Council Ref: D/45-2020
Our Ref: 032-19-20

Re: DEVELOPMENT APPLICATION D/45-2020 FOR A MATERIAL CHANGE OF USE FOR A TRANSPORT DEPOT –
SITUATED AT 162 MIDDLE ROAD, GRACEMERE – DESCRIBED AS LOT 102 ON RP604012, PARISH OF
GRACEMERE

Response to Information Request

Stormwater Management Plan

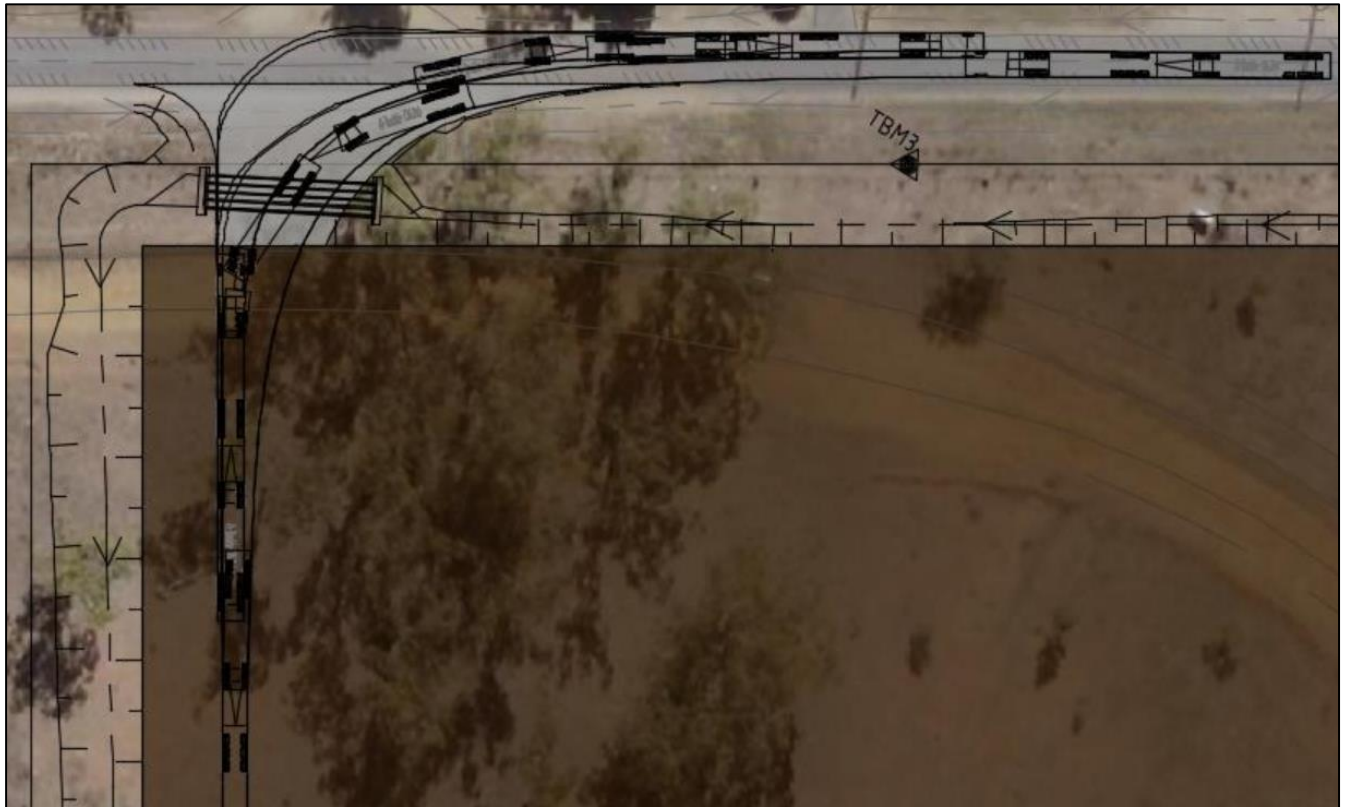
1.2 Council is concerned that vehicles egressing the site will be unable to stay within the sealed portion of Douglas Street. As such, please provide swept paths for the largest vehicle accessing the site relative to the existing pavement width and proposed accesses. It is acknowledged that a basic swept path is shown on Drawing SK-002 however it is not clear what type of vehicle this represents.

Road Trains will access site at the western access see below for swept paths. Access design to be provided as part of future Operational Works applications.
